# Conceptual Review Agenda

Schedule for 02/04/13 to 02/04/13

# 417 N Grant Ave Subdivide & SF Homes

# I-25 & Carpenter Rd

S H I F F L E R A S S O C I A T E S A R C H I T E C T S , P . L . C .

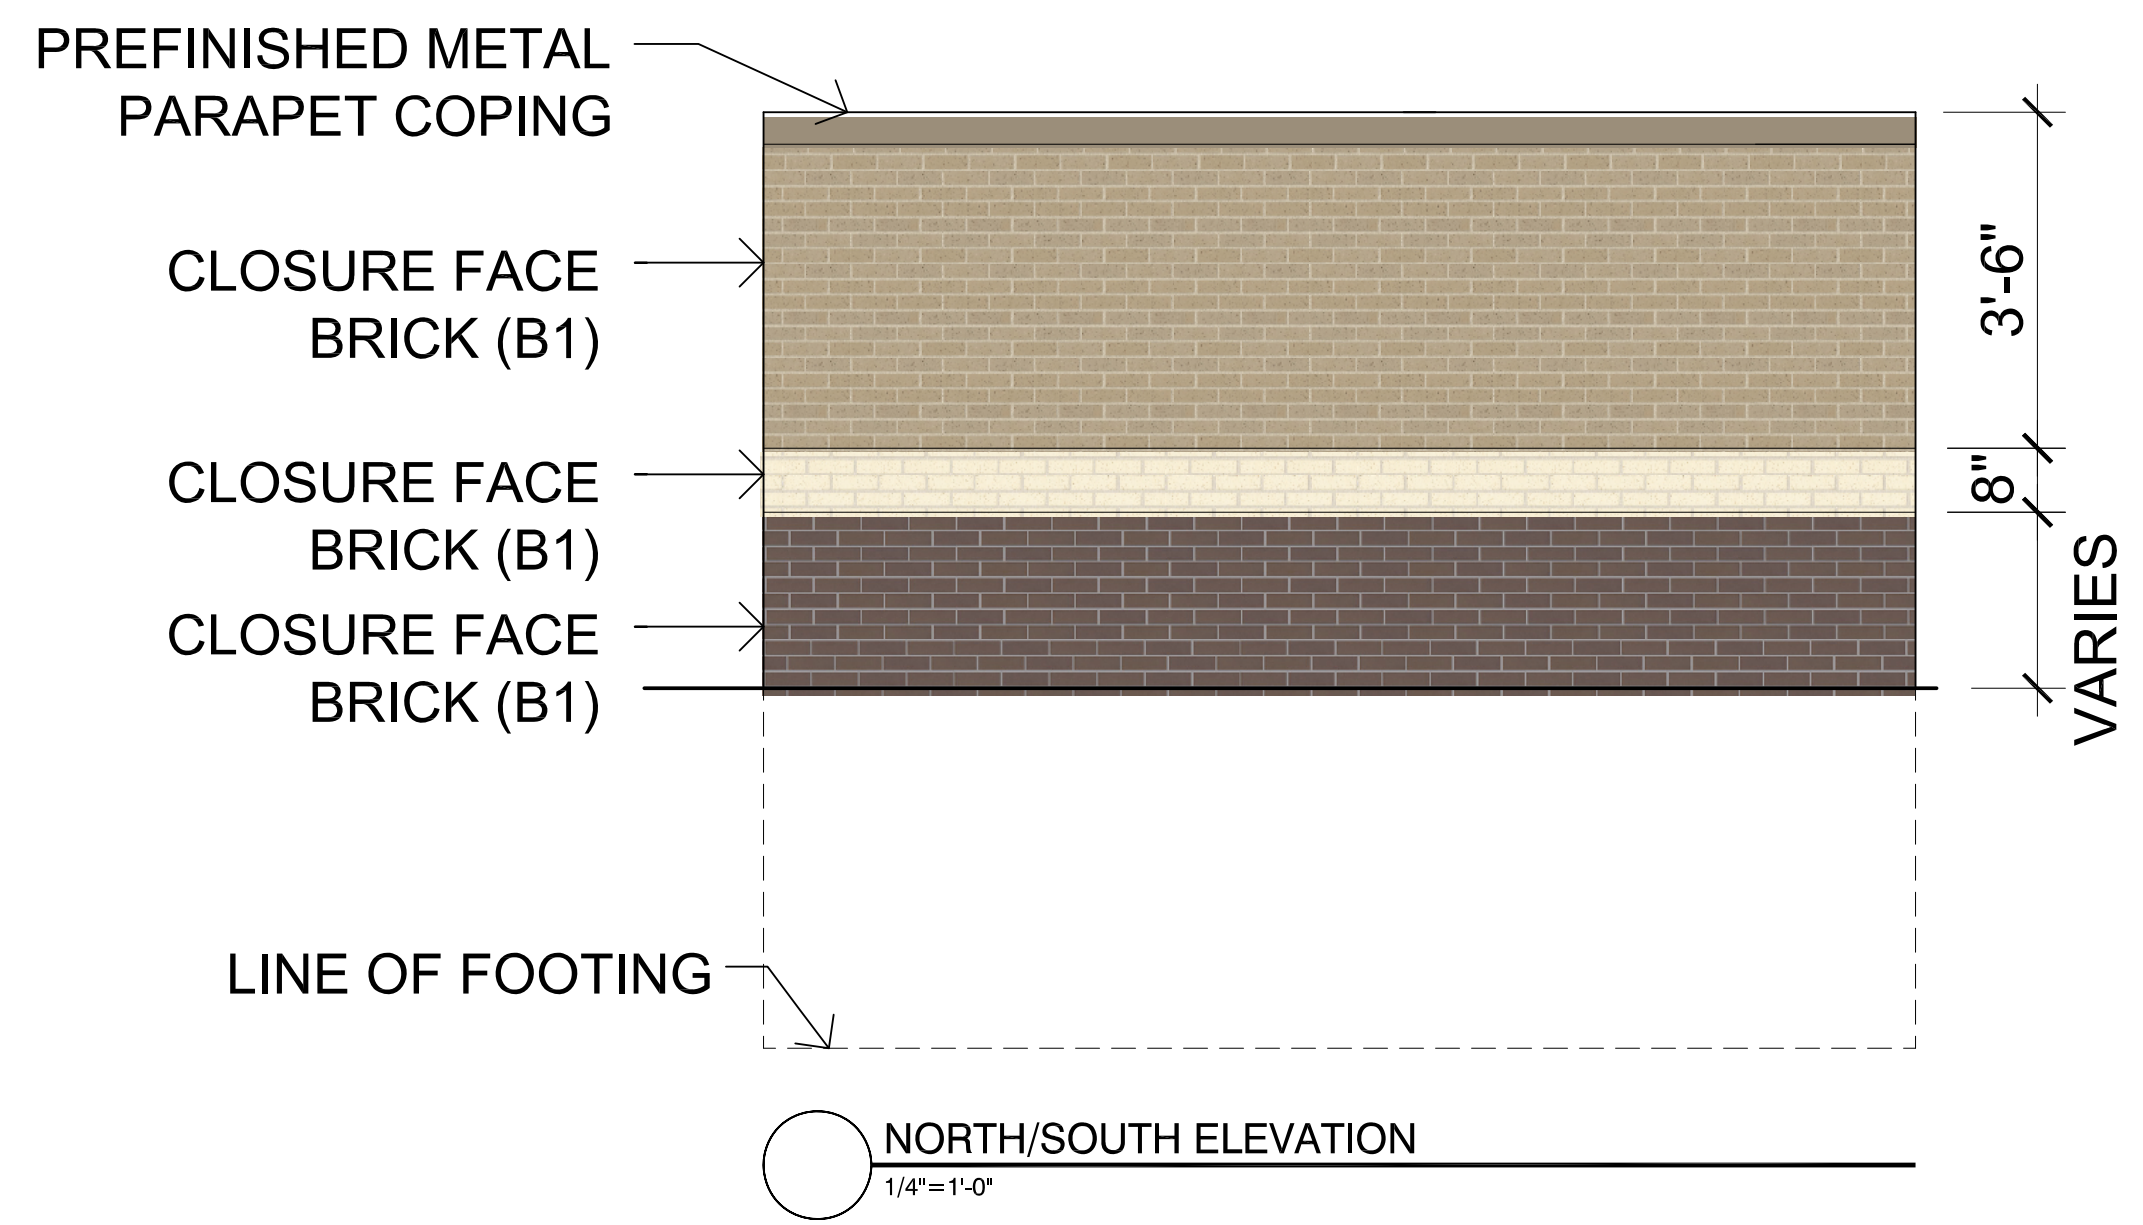
10. Please note that Section 3.5.3(D)(4) allows for the modification of a standardized prototype design in order to promote a distinctive urban design for the Corridor Activity Center. With regard to the canopy, therefore, white painted columns would need to be re-designed to feature the masonry material used on the building. Also, Section 3.9.5(C) requires colors to be of low reflectance.
